#07-06-04-003: LSJ, L61, LK5, L52, LL8 Engine - Reduced Engine Power, MIL/SES Light, DTC P1516, P2135, P2138 (Replace PCM) - (Jan 19, 2007)

Subject: LSJ, L61, LK5, L52, LL8 Engine — Reduced Engine Power, MIL/SES Light, DTC P1516, P2135, P2138 (Replace PCM)

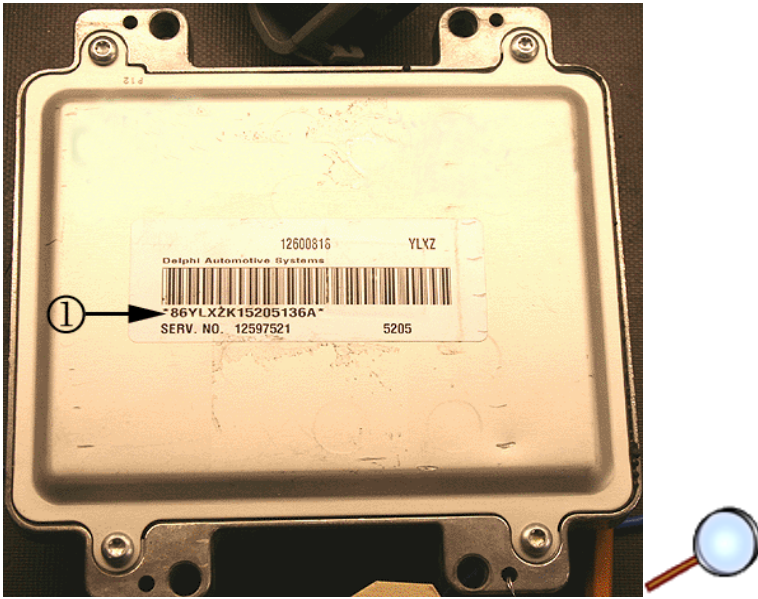
Before following the diagnostic information in SI on DTCs P1516, P2135 and/or P2138, an inspection of the PCM serial number year and Julian (PCM build) date will be necessary to determine if the PCM will need to be replaced to correct the repeat DTC P1516. Refer to Engine Control Module Replacement in SI in order to remove the PCM. Refer to the above graphic illustration (1) for the location of the PCM serial number.

The serial number is read left to right. The last digit of the year is the 9th character and the Julian date is comprised of the 10th, 11th and 12th characters and is used to determine the PCM build date. Refer to the example below to read a build date from the PCM serial number:

If the PCM year and Julian dates are between 5182 and 5304, replace the PCM. Refer to the Part Catalog to order the correct PCM for your vehicle application, if necessary.
